U. S. ATOMIC ENERGY COMMISSION  
REGION II  
DIVISION OF COMPLIANCE

Report of Inspection (Vendor)

CO Report Nos. 50-261/69-5  
50-247/69-4  
50-286/69-4  
50-250/69-6  
50-251/69-3  
50-244/69-6  
50-266/69-4  
50-301/69-3

An announced inspection was made at the Westinghouse Electric Corporation, Lester, Pennsylvania, plant. The purpose of the visit was to determine the quality level of the manufactured products and the essential documentation. The inspection was limited to the steam generators. (The pressurizers are being fabricated in Tampa, Florida.)

# -7 NUT PLATE

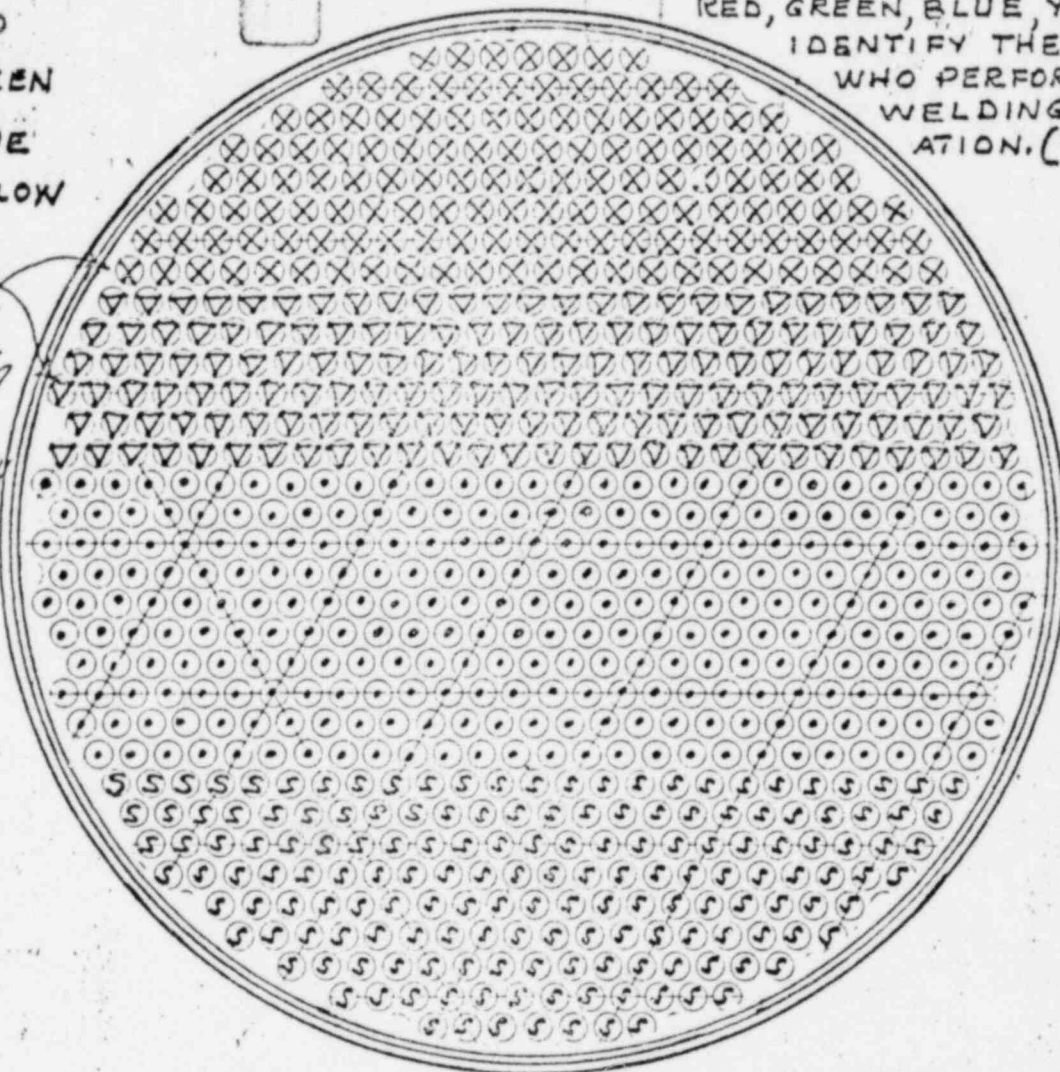
1. Open cans of low-hydrogen electrodes were seen in the stockroom and in the shop welding area, and workers were observed obtaining a supply from the open cans. (See Section G. 1.)
2. The -7 nut plates on the channel heads of the steam generators (Drawing 679-J-442) were not stress relieved or magnetic particle (MT) inspected as called out on the drawing. The above requirement apparently has been overlooked on all steam generators fabricated to date. (See Section G.2.)  
*G.2.*

The inspector's mention of this item was accepted with only minor comment. Westinghouse stated that although it was an oversight, stress relieving and magnetic particle inspections would be performed in the field.

*744-5 material?*  
The shop was very well organized, with the nuclear work on one end of the building and the nonnuclear occupying the other half. The first items inspected were the insulation nut plate attachments (under ASME Section III, N518.3 and N518.4) on the channel heads. The inspector inquired of Klossin and Earle if the nut plates on the channel heads (attachments) were inspected. Klossin stated that there were no inspection requirements and proceeded to check the applicable drawing. Westinghouse Drawing 679-J-442 indicated that the 1/4-inch fillet welds were fabricated to Specification 600923SR (stress relieve) and 60019MT-F (Magnetic Particle Inspection). (See Exhibit C.) Klossin admitted that Westinghouse had overlooked the drawing callout and Code requirements.

# TUBE-TO-TUBE SHEET WELDS (A)

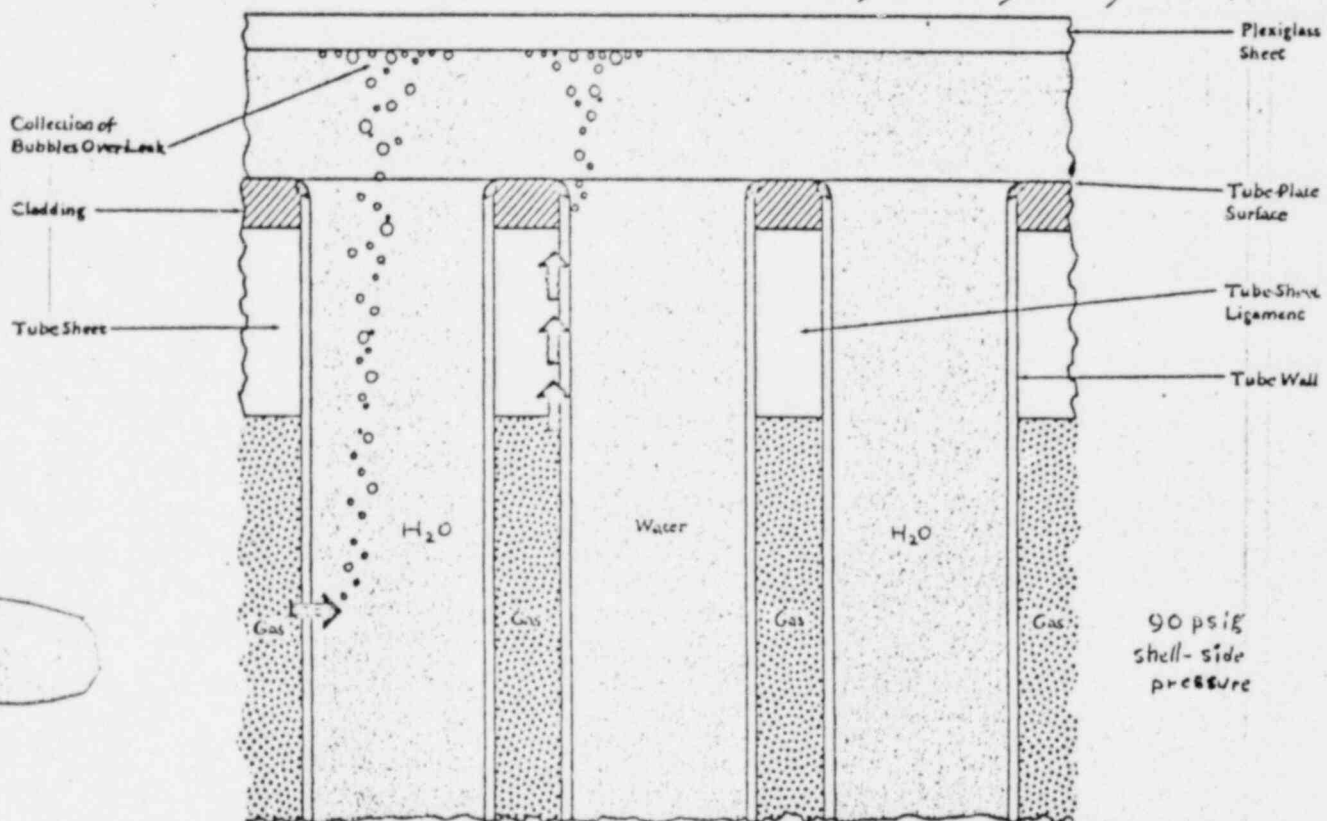
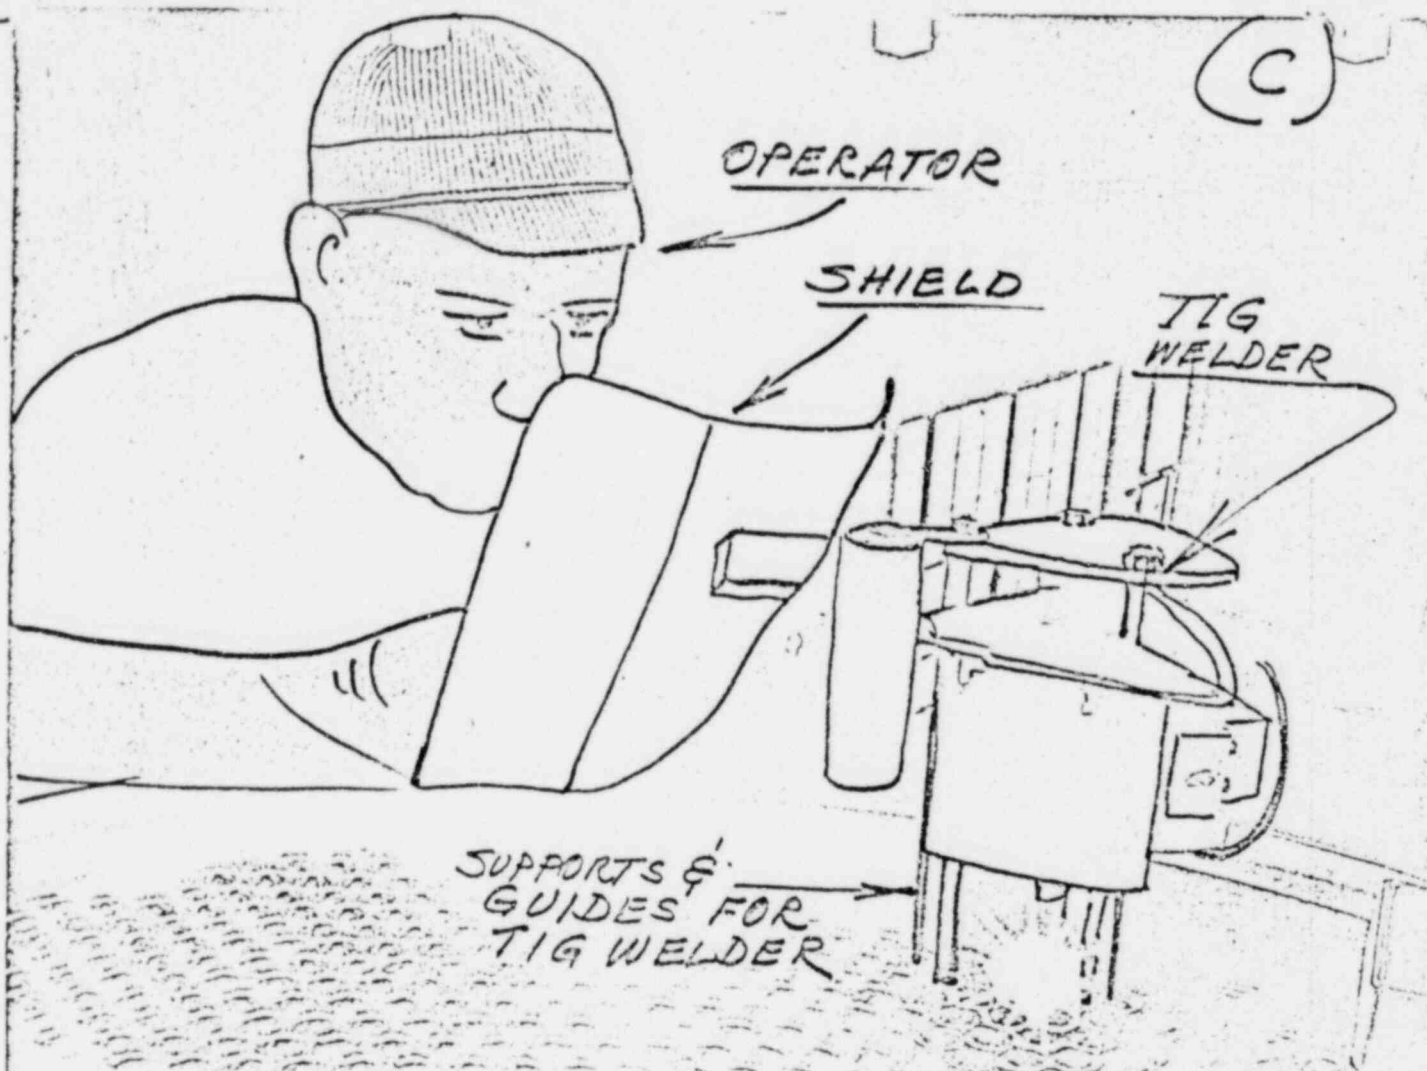
The inspector spent considerable time inspecting and observing the welding of the tube-to-tube plate welds. The Exhibit describes the inspector's observation. According to Westinghouse personnel, they have made over 320,000 tube-to-tube plate welds without experiencing a failure; and this is why Westinghouse now offers a five-year warranty against leakage of welded joints between tubes and tube-plate on all domestic orders.
